Change Notice Information Announcement

Product Name(s): TeSys GV2L & GV3L

Product Line Description: Manual Starter & Protector

Document Issued: 11/19/2019

Product Photos

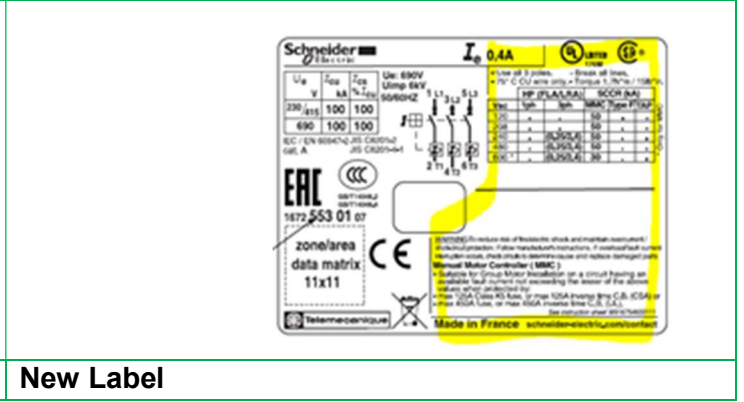
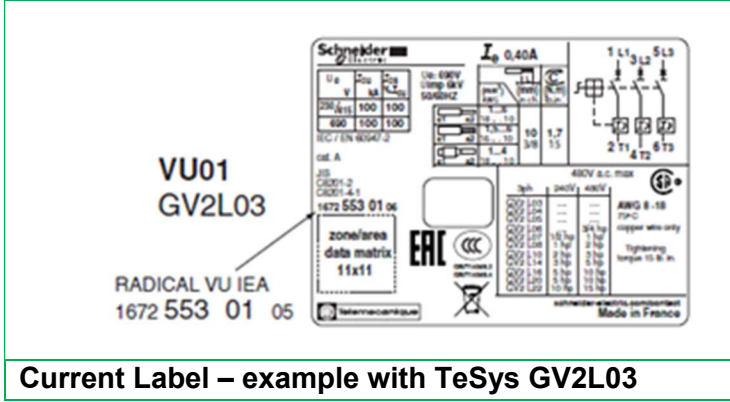
Description of Change:
 There is new certification for offers TeSys GV2L and GV3L which has an impact on the product markings (UL&CSA logos and performances), individual box markings, and instruction sheets.
Product Certifications Impacted:
 UL for Manual Motor Controllers -
 1) Model GV2, followed by L or LE, followed by 03, 04, 05, 06, 07, 08, 10, 14, 16, 20 or 22.
 2) Model GV3L, followed by 25,32,40,50,65 or 73 may be followed by 6 or 1.
 CSA for Manual Motor Controllers -
 1) Model GV3L, open type, 3 pole-3 ph, with non-adjustable thermal and magnetic trip, Cat. Nos. GV3L25 to GV3L73 for use in conjunction with certified overload relay.
